To: Plan Holders for Improvements to the
Kirksville Regional Airport
Kirksville, Missouri
Project No. 14-028A-3
Reconstruct Air Carrier Apron (Schedule I), Reconstruct South Apron (Schedule II),
and Reconstruct T-Hangar Taxilanes (Schedule III)

Transmitted herewith is Addendum **No. 2** to the Contract Documents, Plans and
Specifications dated May 19, 2015 for Improvements to the Kirksville Regional
Airport, Kirksville, Missouri, Project No. 14-028A-3.

**ADDENDUM NO. 2
TO
CONTRACT DOCUMENTS, PLANS AND SPECIFICATIONS
FOR IMPROVEMENTS TO THE
KIRKSVILLE REGIONAL AIRPORT
KIRKSVILLE, MISSOURI
PROJECT NO. 14-028A-3**

SHEET NAME
G002
SHEET NO.
2 of 32

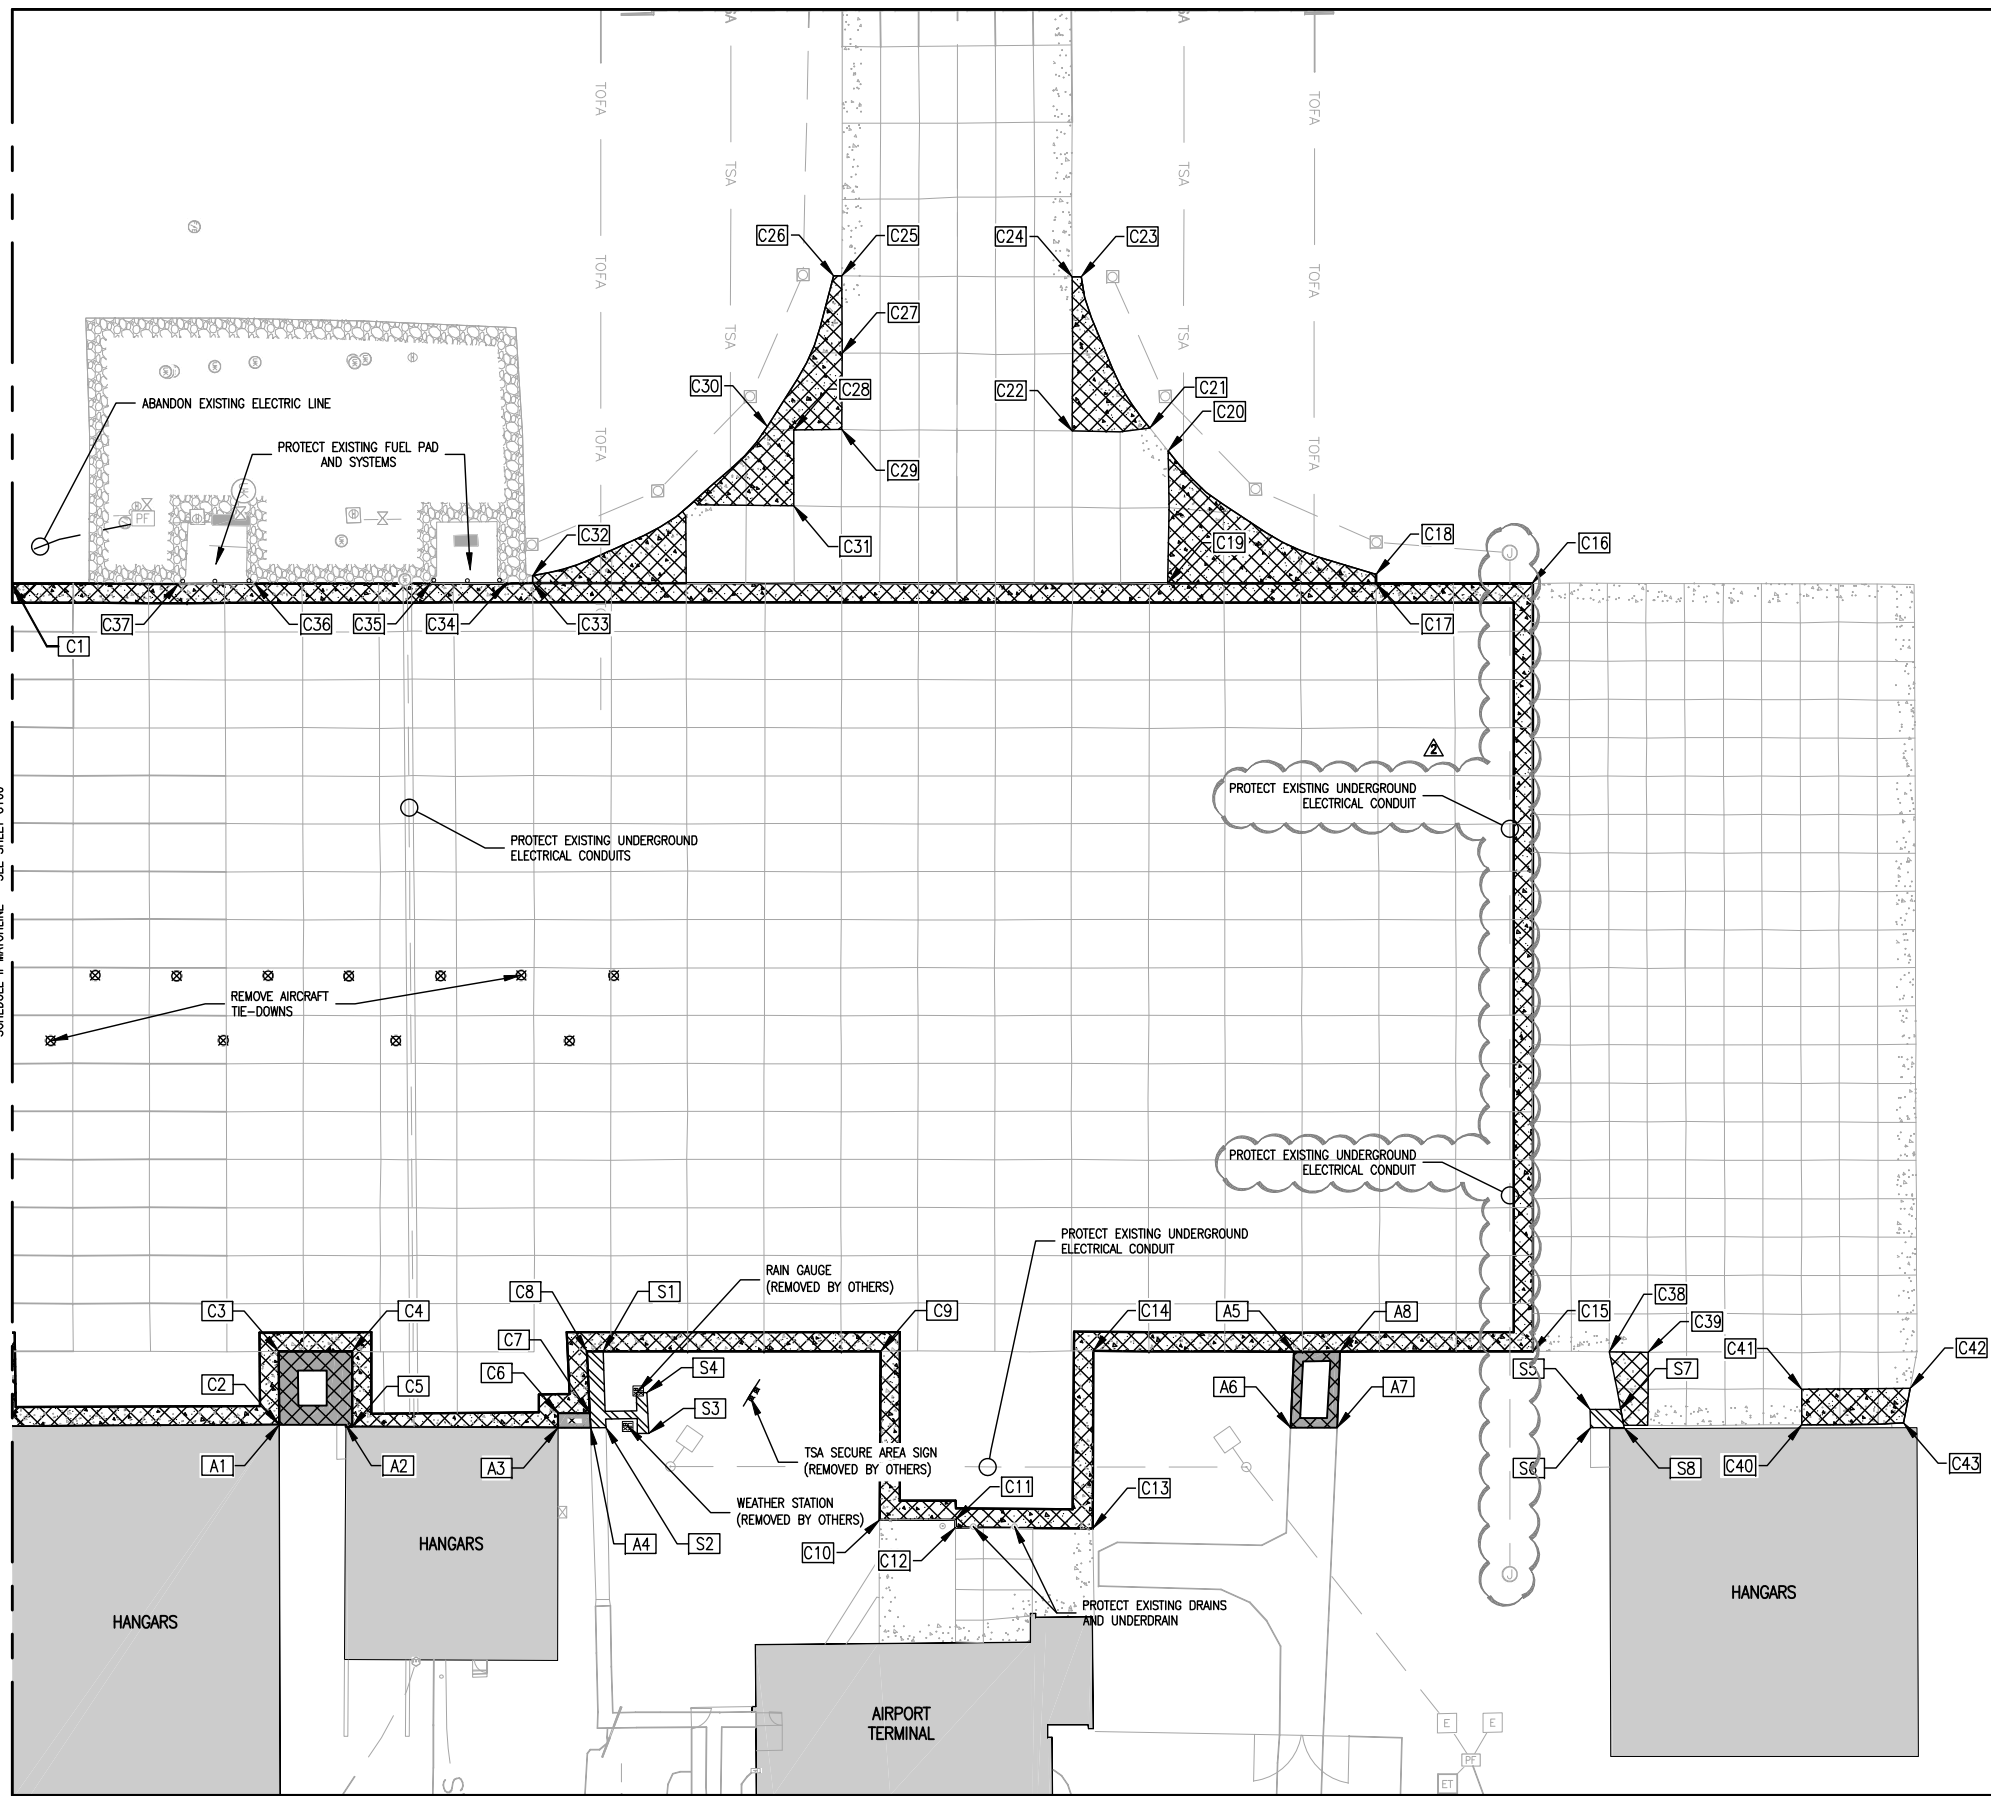
Sheet: G002
Title: Index of Drawings, General Notes, and Summary of approximate Quantities
Revision: The Summary of Approximate Quantities has been revised to reflect the two Bid Alternates.
See attached sheet G002.

SHEET NAME: C101
 SHEET NO.: 12 of 32

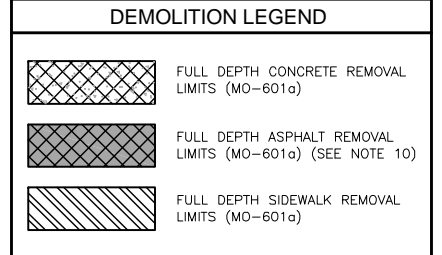
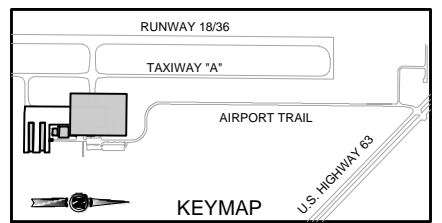
Sheet: C101
Title: Demolition Plan, Schedule I
Revision: The location of the existing underground electrical conduit at the north end of the project area was corrected.
See attached sheet C101.

SHEET NAME
C200
SHEET NO.
14 of 32

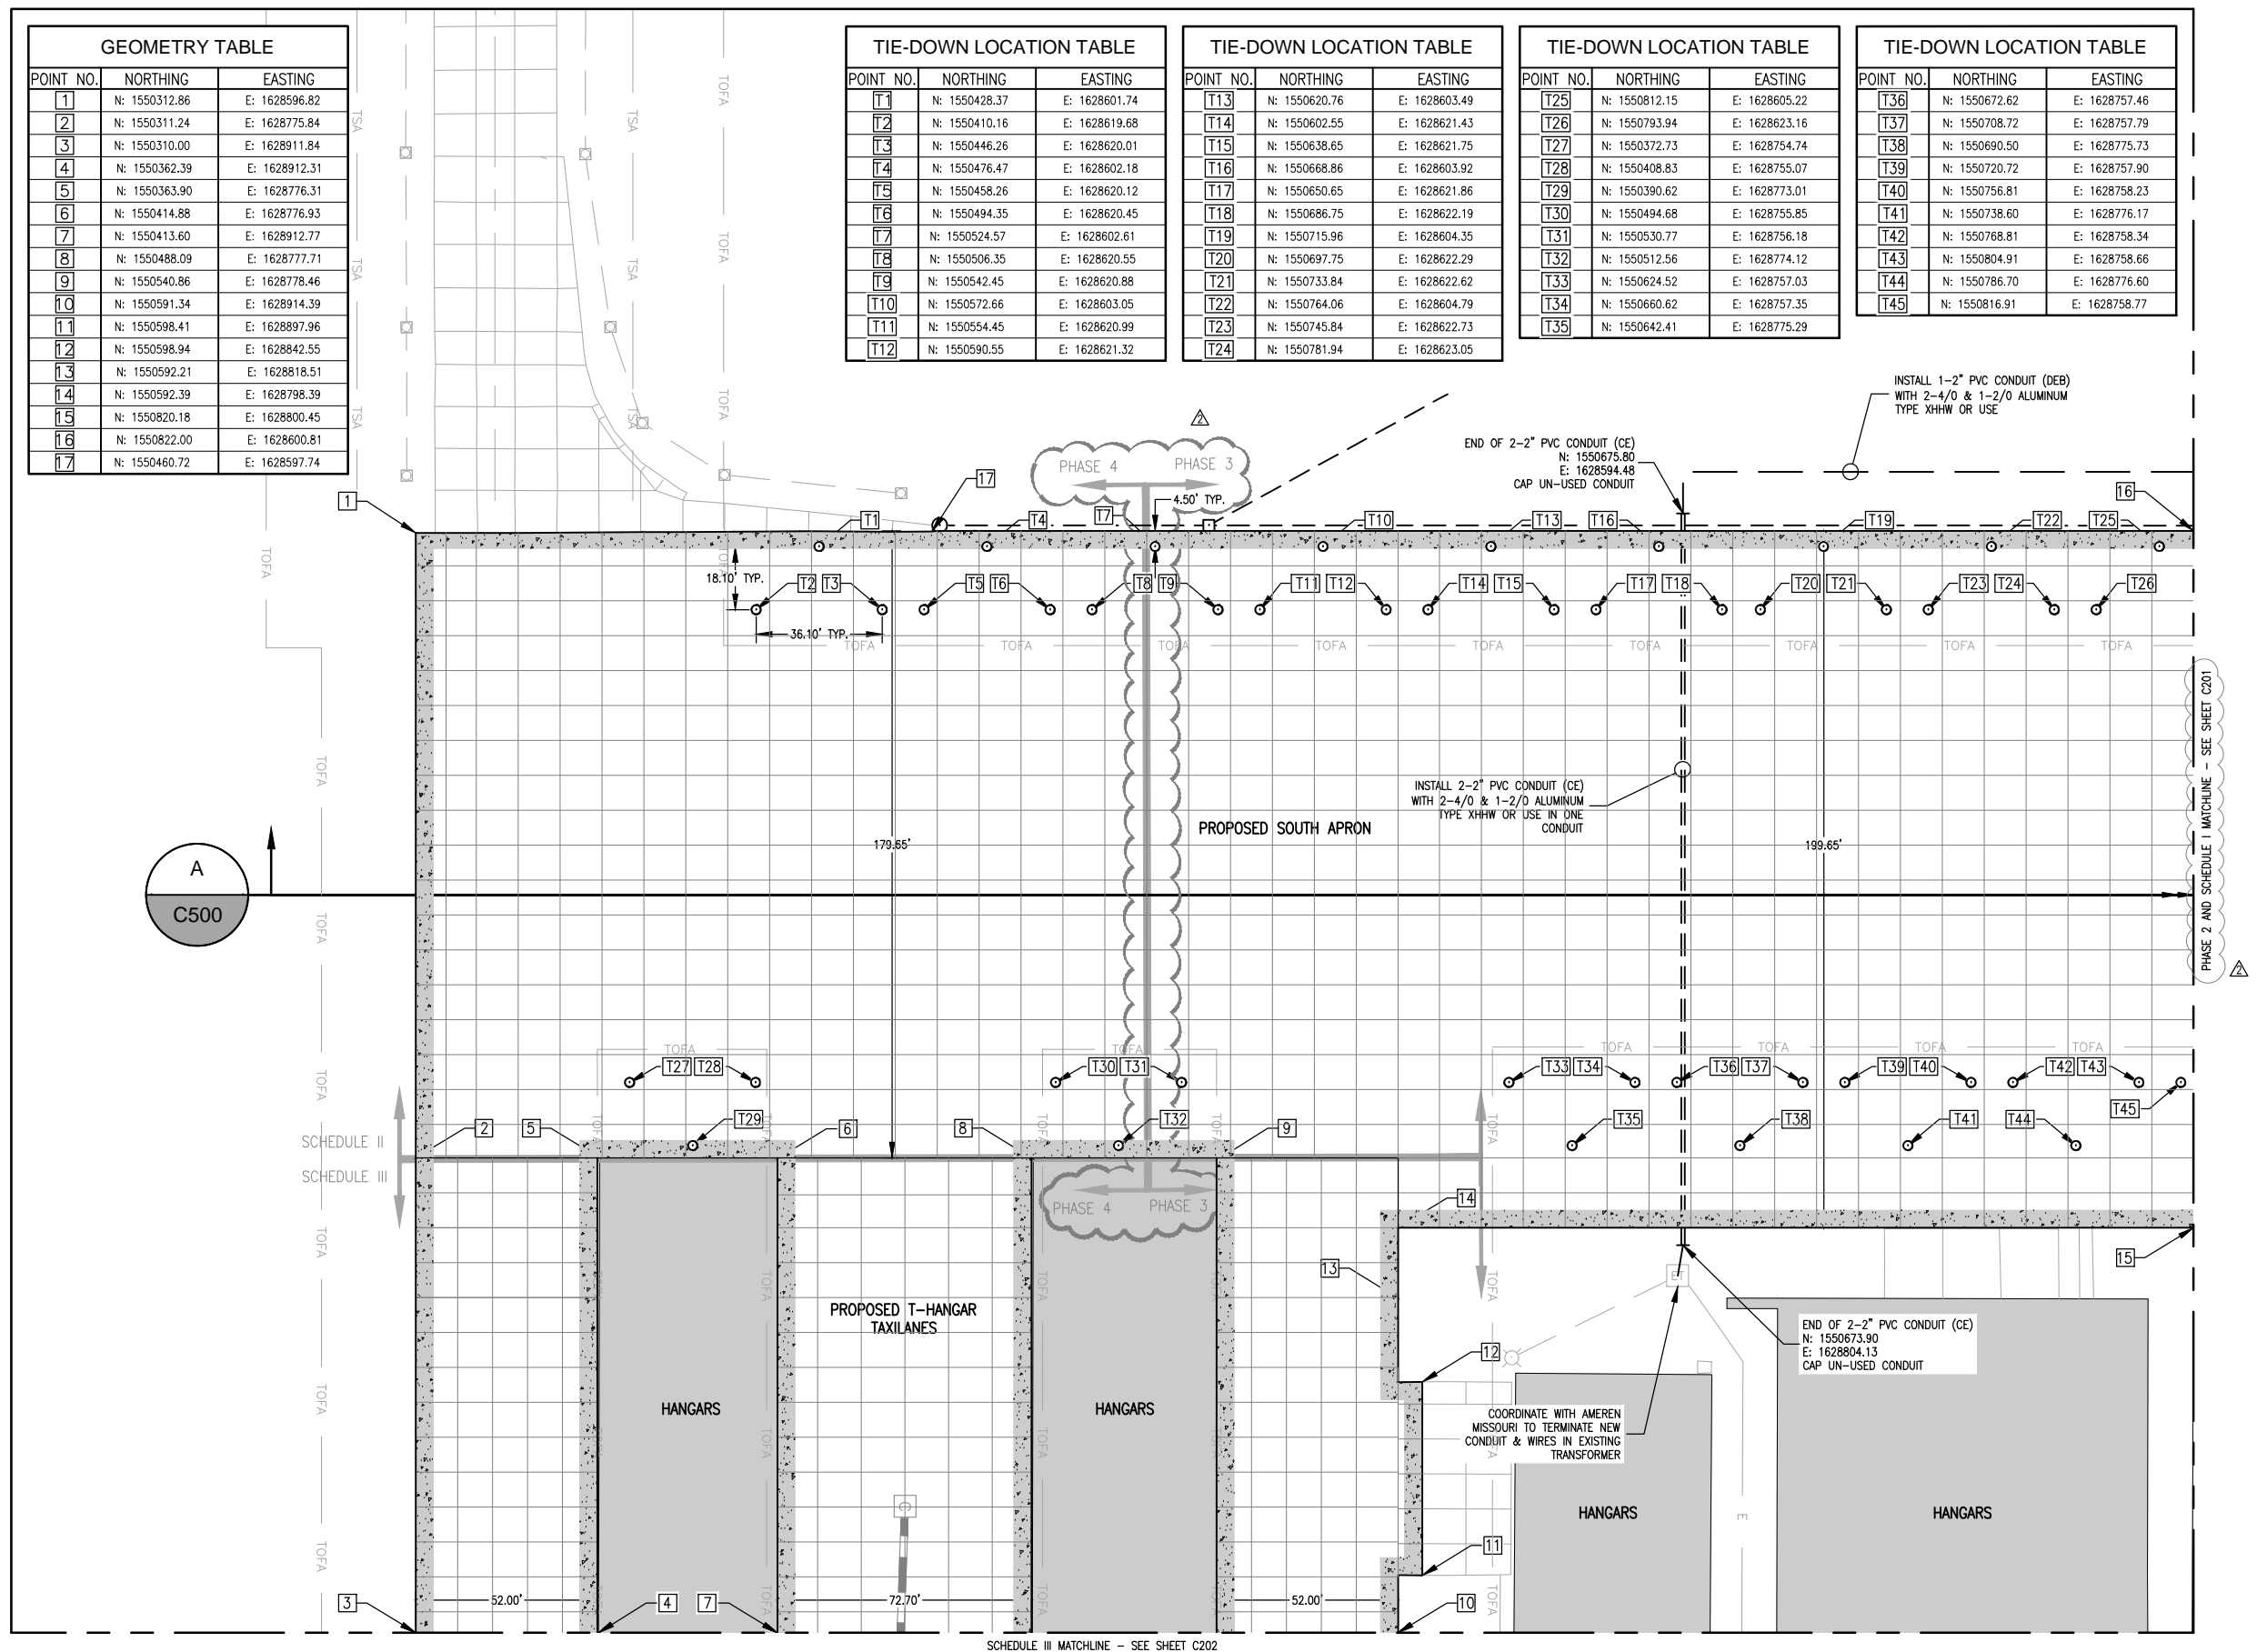
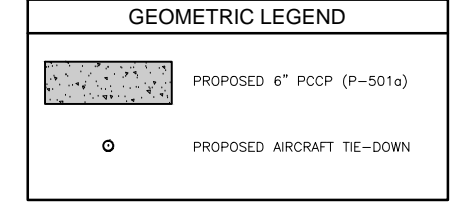
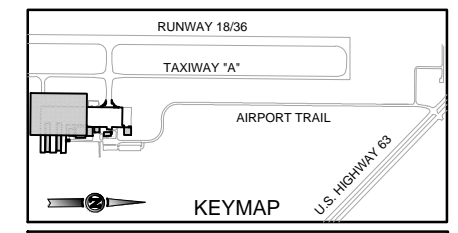
Sheet: C200
Title: Geometric Plan, Schedule II & III
Revision: The location of the phasing breaks has been added.
See attached sheet C200.

2. With the phasing splitting the schedules up there is no detail on the plans (demo, geometric, grading, or joint) showing the limits of each phase. This information would be a great help for both bidding and construction. Could you possibly show the limits of these so we know where to remove and replace to for each phase?

Answer: See revised plan sheets C200 and C201.
